**WCAP-16996-P, "Realistic LOCA Evaluation Methodology Applied to the Full Spectrum of Break Sizes
(FULL SPECTRUM LOCA Methodology)"
Requests for Additional Information – (Non-Proprietary)
RAIs 46 – 58, 75, and 77**

October 2013

Westinghouse Electric Company LLC
1000 Westinghouse Drive
Cranberry Township, PA 16066

Figure 1: Comparison of WCOBRA/TRAC-TF2 T_{CHF} Criterion with Various Correlations and Experimental Data

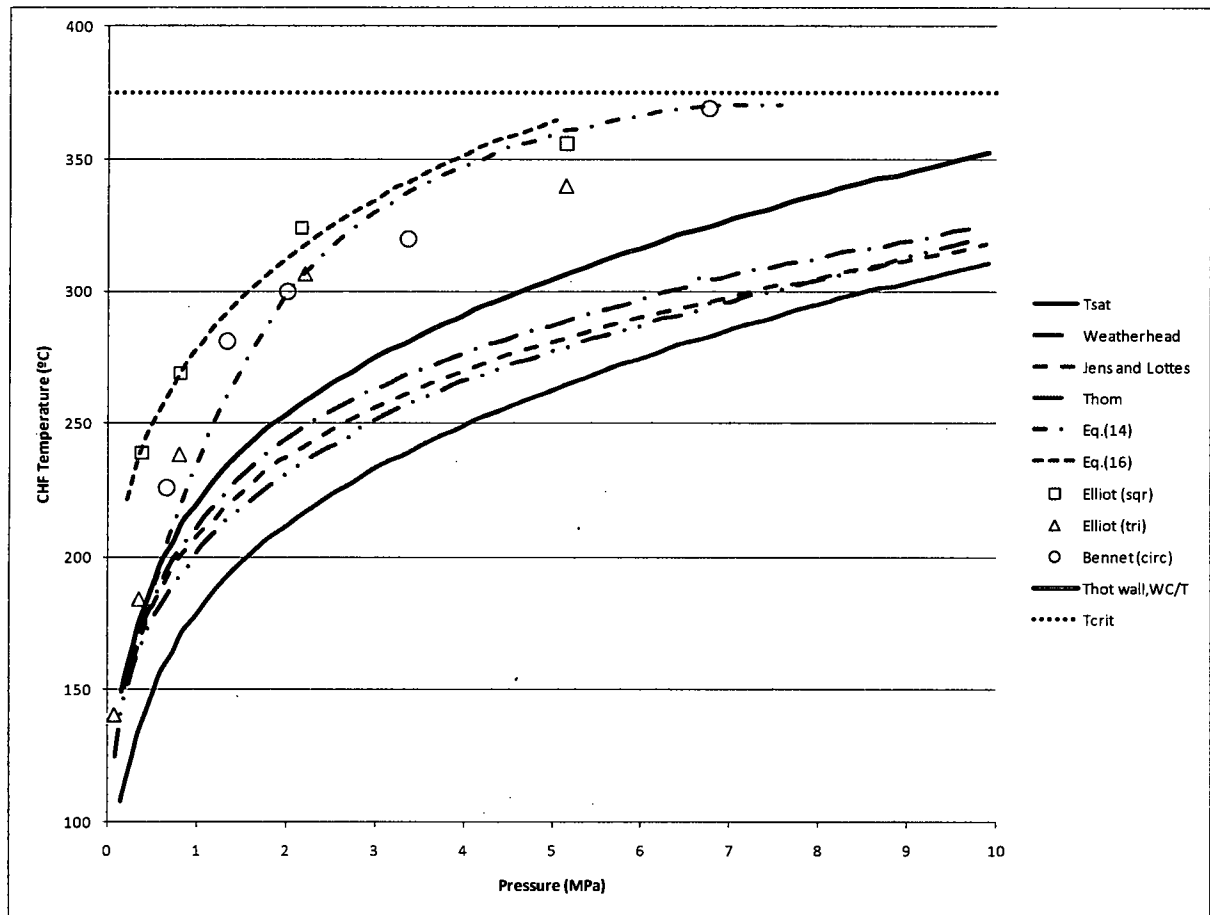
Question #58: Flow Regime Map Selection Criterion for Vessel Component

Carbajo (Carbajo, J., 1985 [4]) noted that the most significant contributor to T_{CHF} was the pressure. He compared T_{CHF} to various correlations and experimental data as a function of pressure. This comparison is presented as Figure 1, with the addition of the $T_{CHF} \approx T_{SAT} + 75^\circ F$ criterion.

The value of T_{CHF} for selection of the flow regime is expected to be less significant under SBLOCA conditions. Given the interface between the two-phase level and single-phase vapor, the cladding will heatup, and the flow regime will switch from cold wall to hot wall at the point where the transition to single phase vapor occurs (Figure 2). As such, application of Equation 4-1 is also judged to be acceptable for SBLOCA conditions.
